AMENDMENTS TO THE DRAWING

REMARKS/ARGUMENTS

STATUS OF APPLICATION

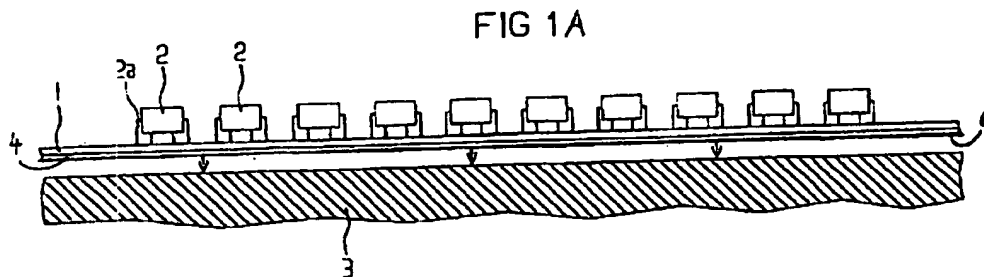
The Examiner points to the specific embodiment of FIG. 2B and what he identifies as "3/1" as being the elongate thermally conductive member.

First, the structure of FIG. 2B is not an elongate structure.

FIG. 2B does not show an elongate structure. The description of FIG. 2B fails to describe any structure that is clearly elongate. Similarly none of the drawings 1A, 2A, 2B, 2D show elongate members since they are all cross sections and as such show only at best a portion of one of the length or width of the member 3. FIG. 1B shows the only PC board 1 in its entirety and the structure is square not elongate. The squareness of the structure of FIG. 1B is easily determined by measuring the length and width of the structure. Little can be determined from the drawing of FIG. 2C since neither the drawing or description shows the cooling member or members 3.

In addition, the Examiner mischaracterizes the structure of FIG. 2B. The plain teachings of the reference clearly describe "3/1" as two separate elements and not as a unitary structure. The arrangement of "3/1" is shown and described more clearly in the alternate embodiment of FIG.1A.

It is clear from the descriptions of the structures of FIG.1A and 2B that **element 1 in all drawings is a plastic or epoxy electrically insulating and thermally insulating printed circuit board.** Element 3 is a thermally conductive member to which printed circuit board 1 is attached with an adhesive layer 6. Layer 4 is a metal layer on the back side of the printed circuit board 1.

It is clear from the drawings that the thermally conductive member 3 does not carry its LEDs 2 on its outer surface. **Rather, the thermally non-conductive printed circuit board 1 carries the LEDs 2.** The Examiner's attention is again directed to the reproduced portions of the reference above which clearly state that the LEDs are carried on the printed circuit board 1 and not on the structure 3.
